Director | Carriageway Consulting Limited

Simplify the Site Plan

Summit Grade

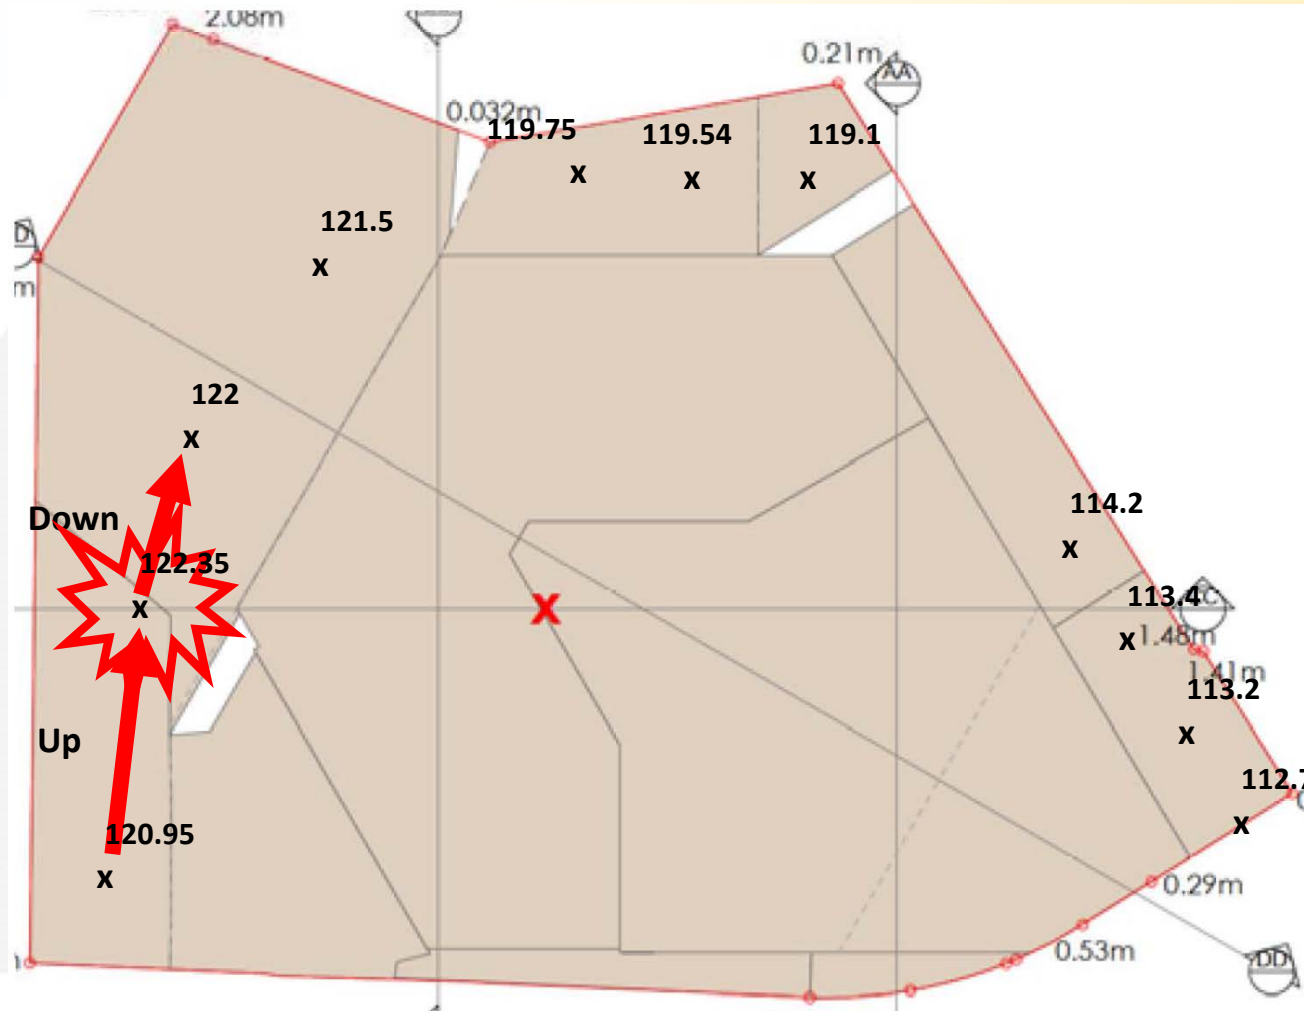
Applicant's plan shows 1 in 11 uphill, changes to 1 in 30 downhill

So total change in angle is 7.1 degrees, which equates to an overall change of gradient of 1 in 8.05

Problem: The maximum change of grade for a coach is 1 in 10.4 and for a service vehicle is 1 in 16 – otherwise they scrape or get jammed

So porte cochere remains unusable by coaches and service vehicles

Second Summit Grade

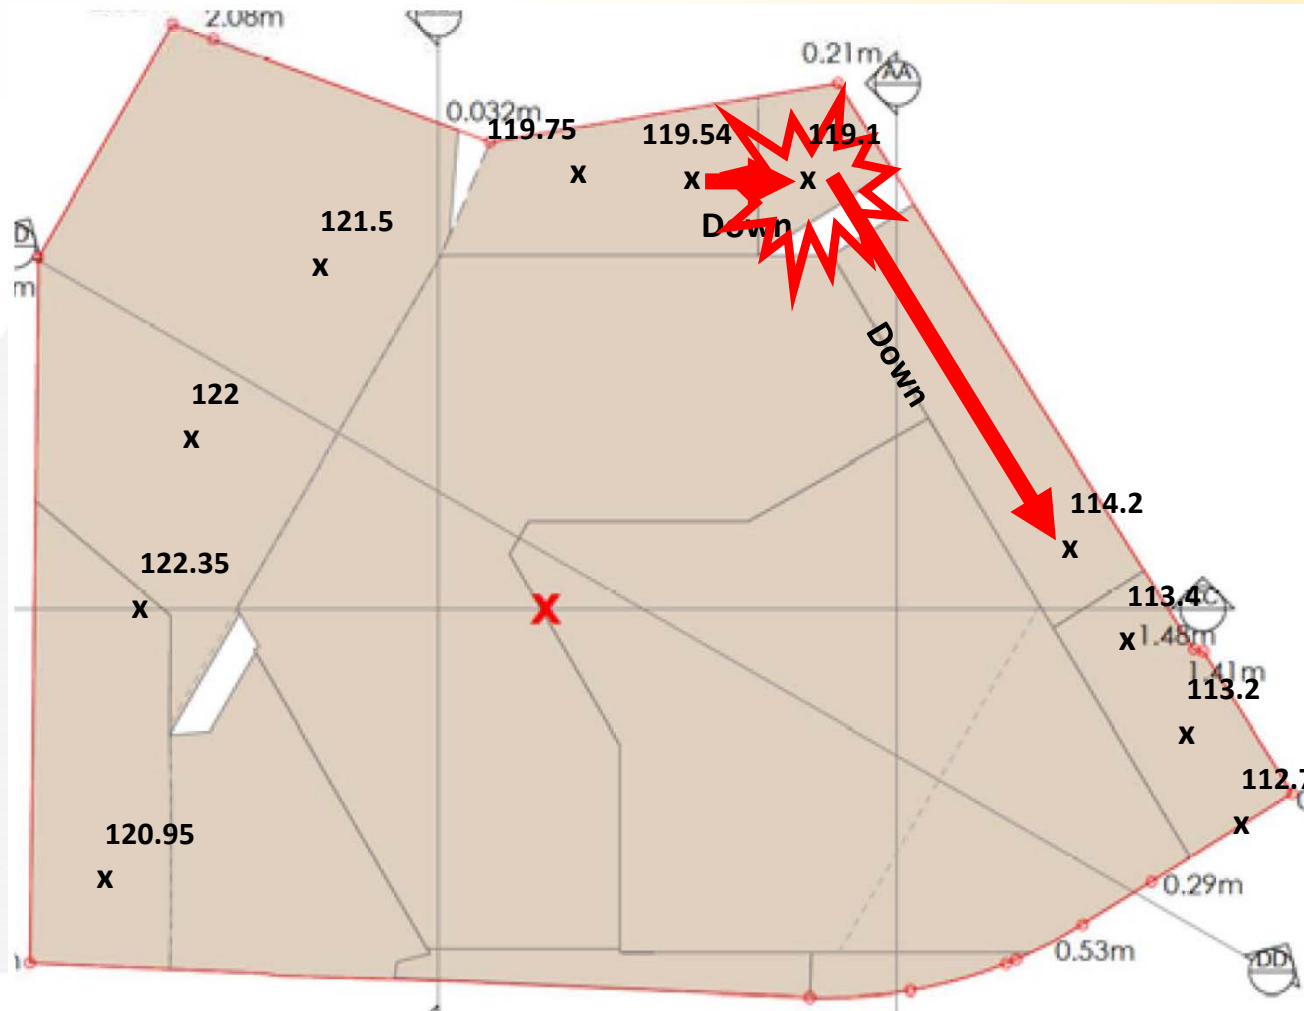
Applicant's plan shows 1 in 11 downhill, changes to 1 in 6 downhill

So total change in angle is 4.3 degrees, which equates to an overall change of grade of 1 in 13.4

Problem: The maximum change of grade for a service vehicle is 1 in 16 – otherwise they scrape or get jammed

So service vehicles are unable to get to the loading bay

Miscalculation of Gradient

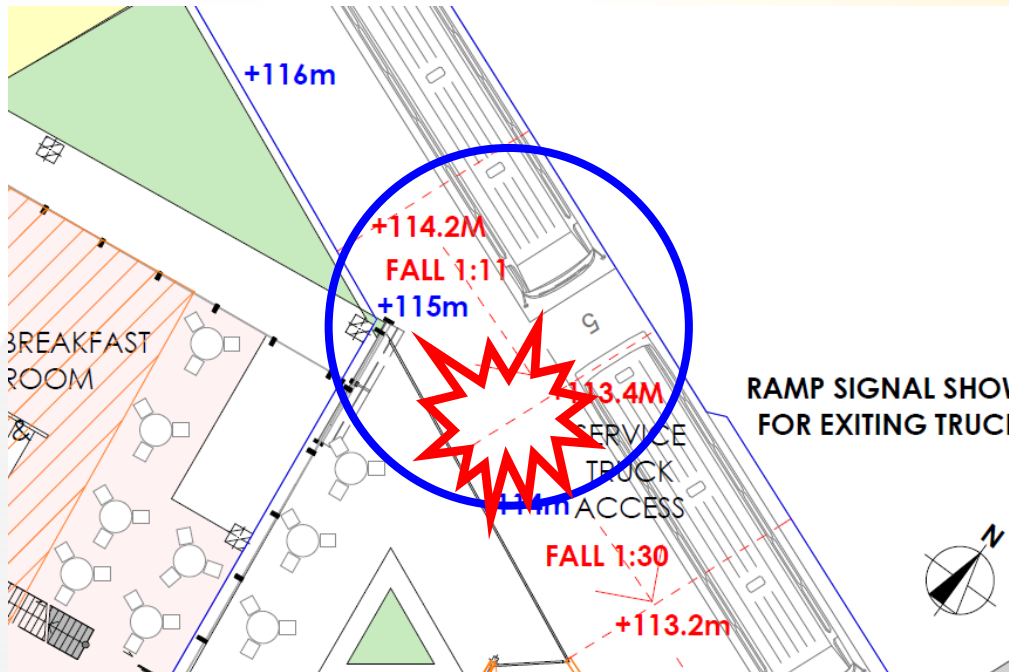
Change in level from 114.2m to 113.4m (0.8m) over a distance of 7m

Equates to a gradient of 1 in 8.8 **not** 1 in 11 as shown

So total change in angle is 4.6 degrees, which equates to an overall change of grade of 1 in 12.5

Problem: The maximum change of grade for a service vehicle is 1 in 16 – otherwise they scrape or get jammed

So service vehicles are unable to get to the loading bay

Loading Bay Access

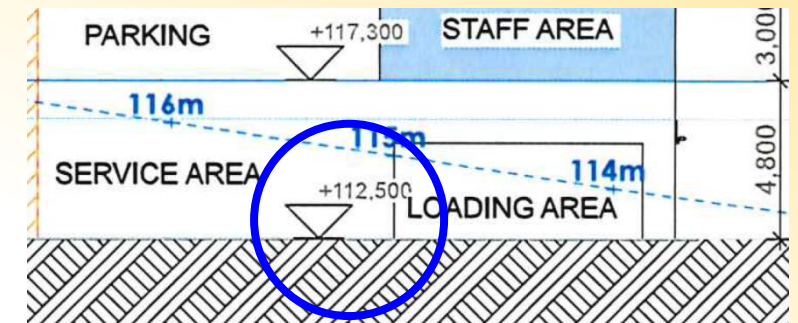
Problem: Levels shown on perimeter road are at least 0.7m higher than the level shown on plan of cross-section

Level of Loading Bay (Option 1)

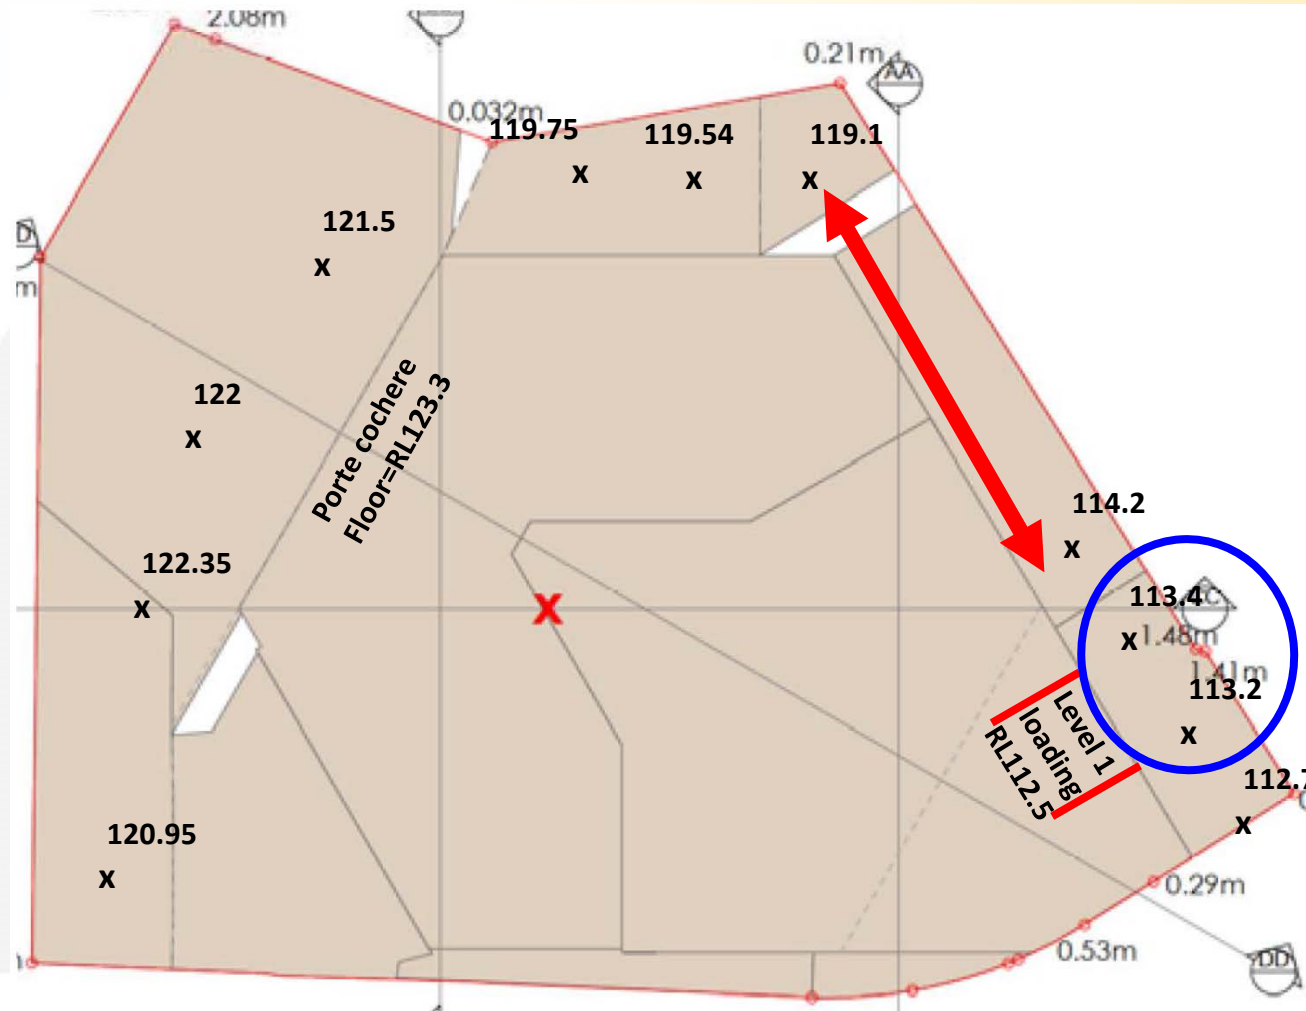
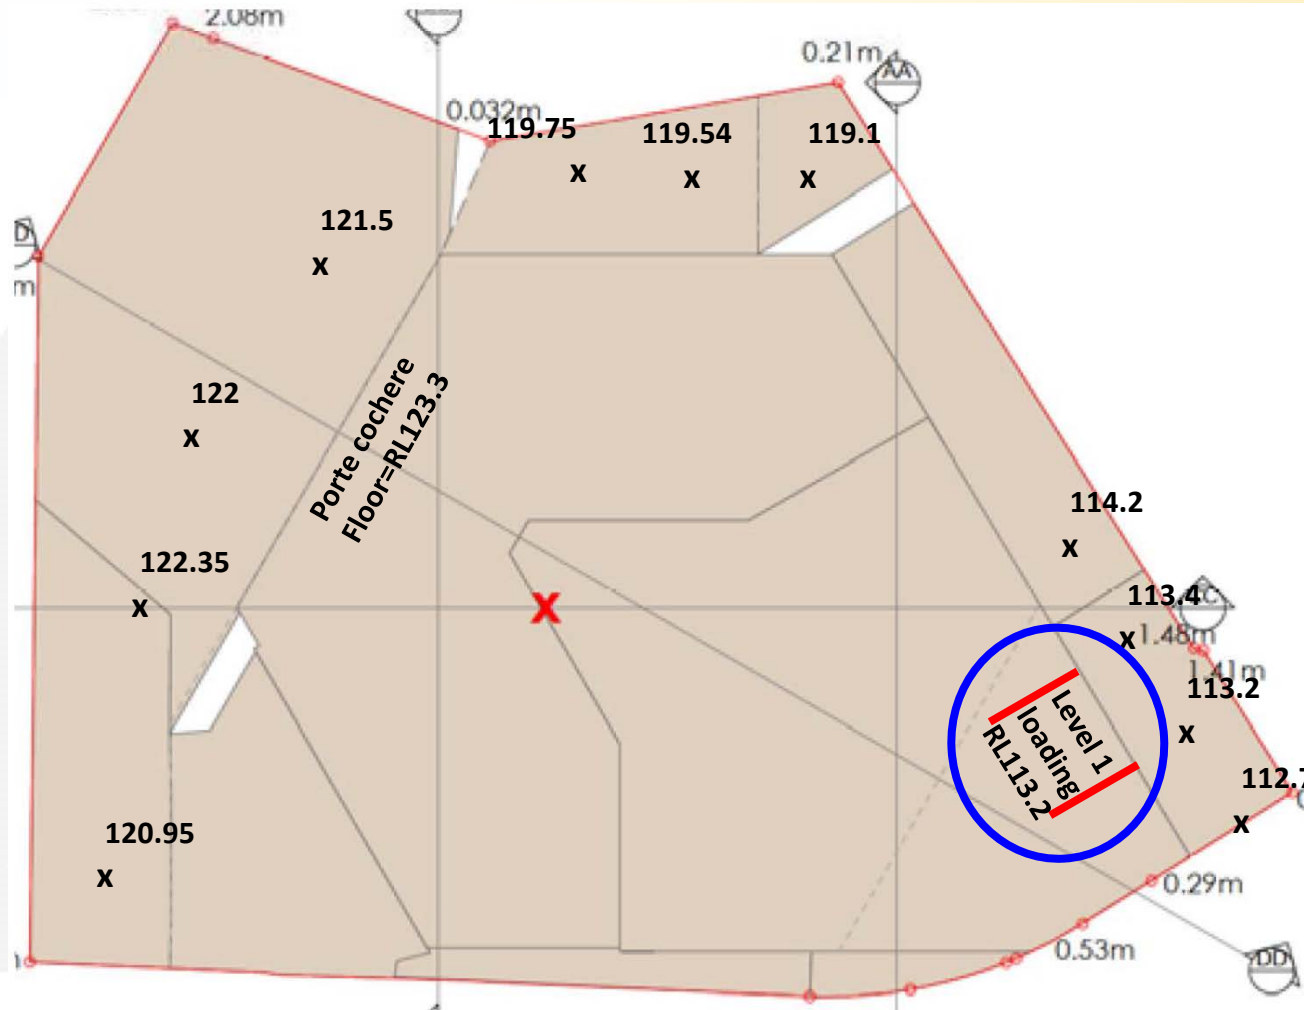
If the loading bay is at RL112.5 as cross-section plan shows, then the adjacent perimeter road needs to be lower

To do this, the gradient of the roadway needs to be steeper

The plans show that this is already 1 in 6

It would need to change to 1 in 5.3

Coaches and service vehicles cannot traverse a gradient of more than 1 in 6.5

Level of Loading Bay (Option 2)

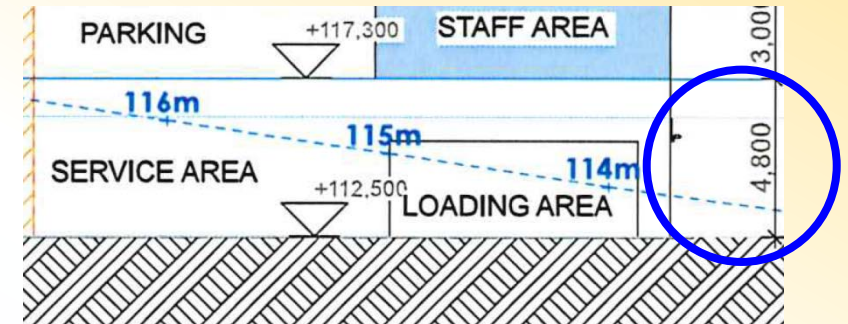
Loading bay could be elevated to the perimeter road (RL113.2)

However, cross-section plan shows 4.8m height clearance provided in loading bay at RL112.5

With the loading bay at RL113.2, this reduces to 4.1m, which is insufficient for a truck

Applicant's Swept Paths at the Loading Bay

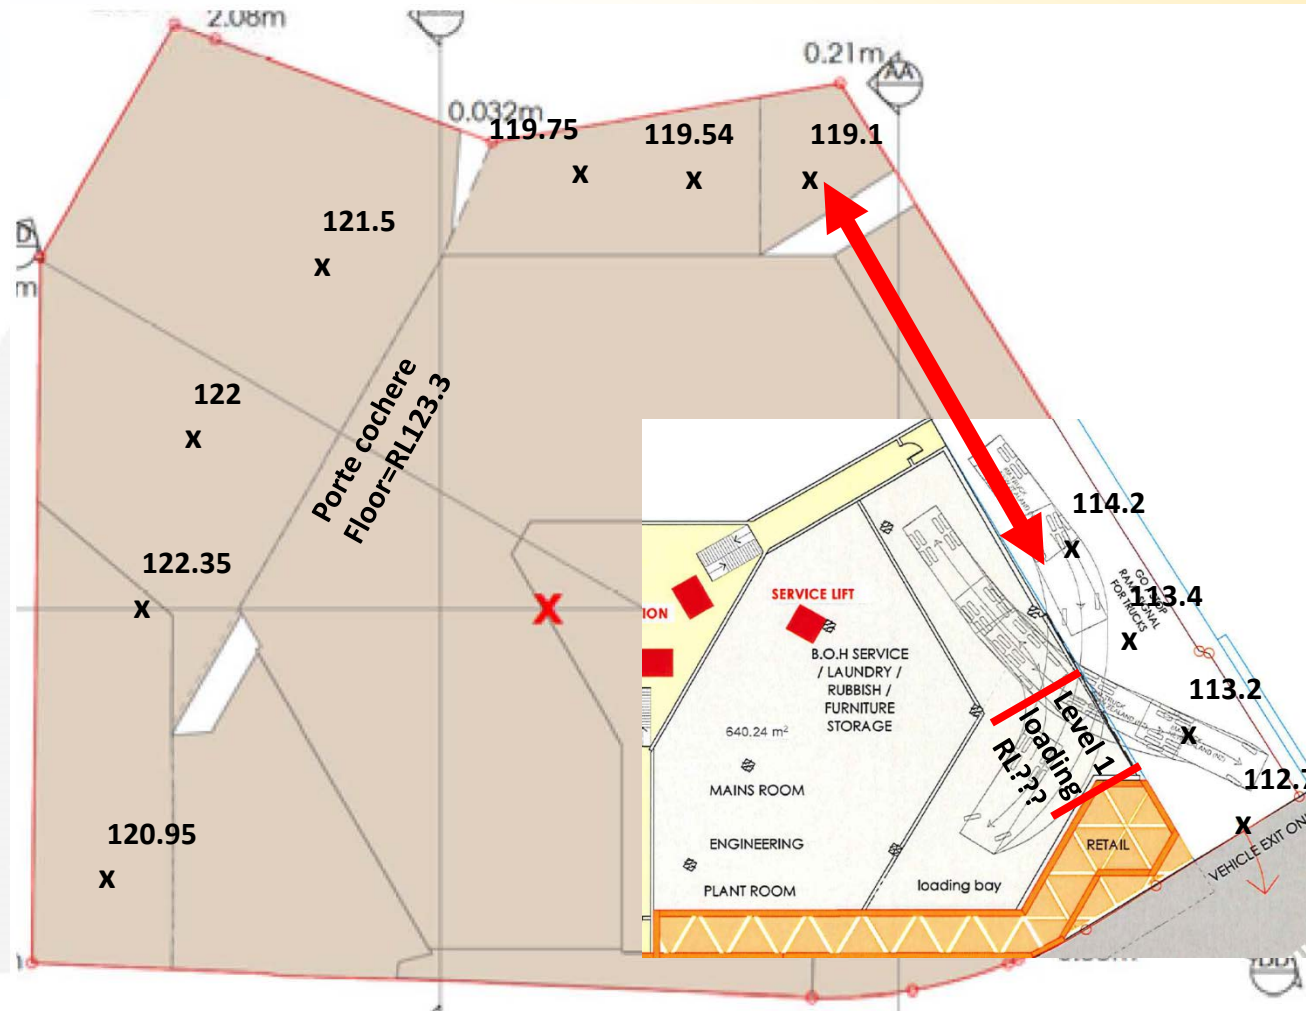
Applicant's own swept paths show the trucks entering the loading bay on the steeper part of the perimeter road (1 in 8.8)

Truck would have severe crossfall with risk of toppling

So this part of the roadway needs to be flatter

Therefore the gradient of the preceding part of the roadway needs to be steeper

But it is already 1 in 6 and steeper than coaches and service vehicles can traverse

Car Park Access

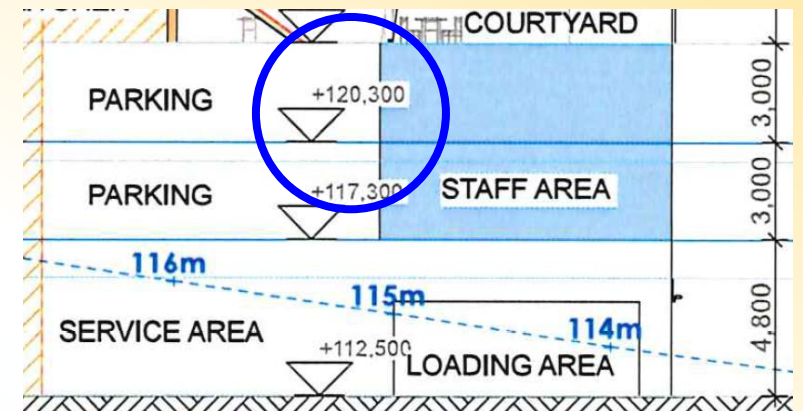
Problem: Levels shown on perimeter road are at least 0.55m lower than the level shown on plan of cross-section

Level of Car Park (Option 1)

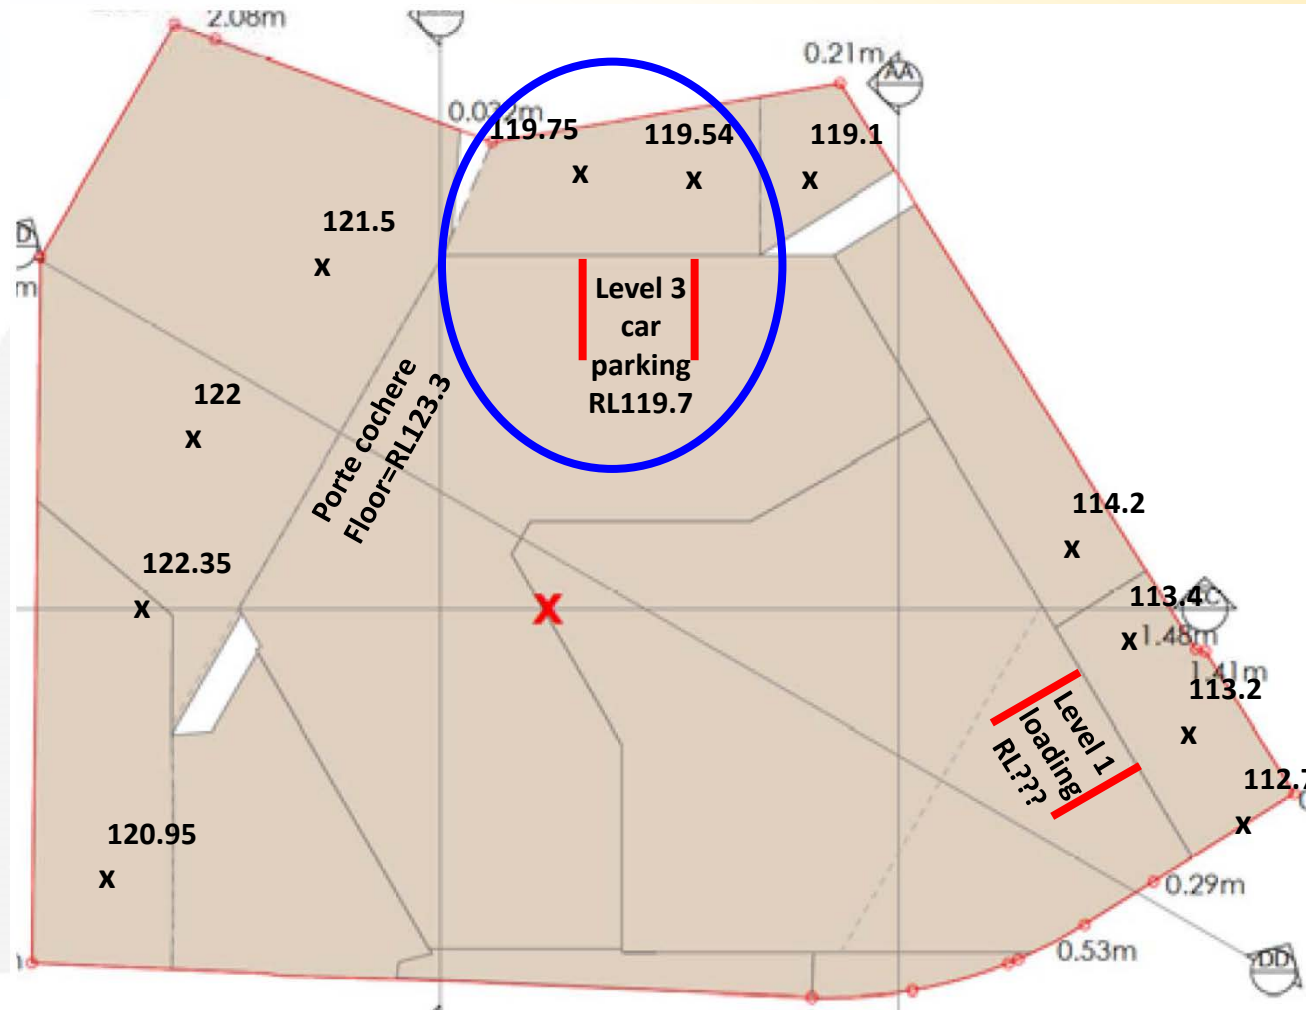
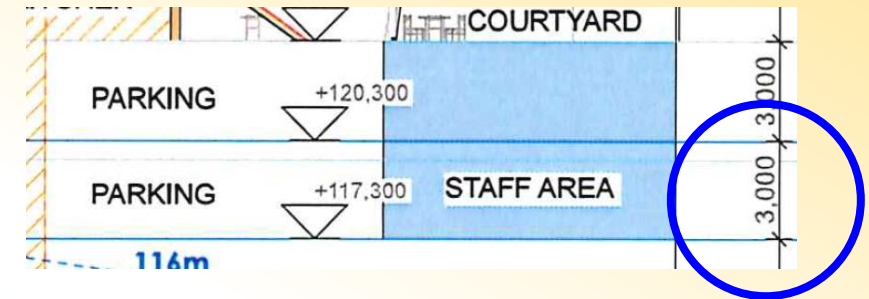
If the level of the car parking is reduced by 0.55m to match the roadway then the height clearance of car parking below reduces to 2.45m

This means headroom of lower level would be 2.15m (allowing 0.3m floor depth) which is too low for cars
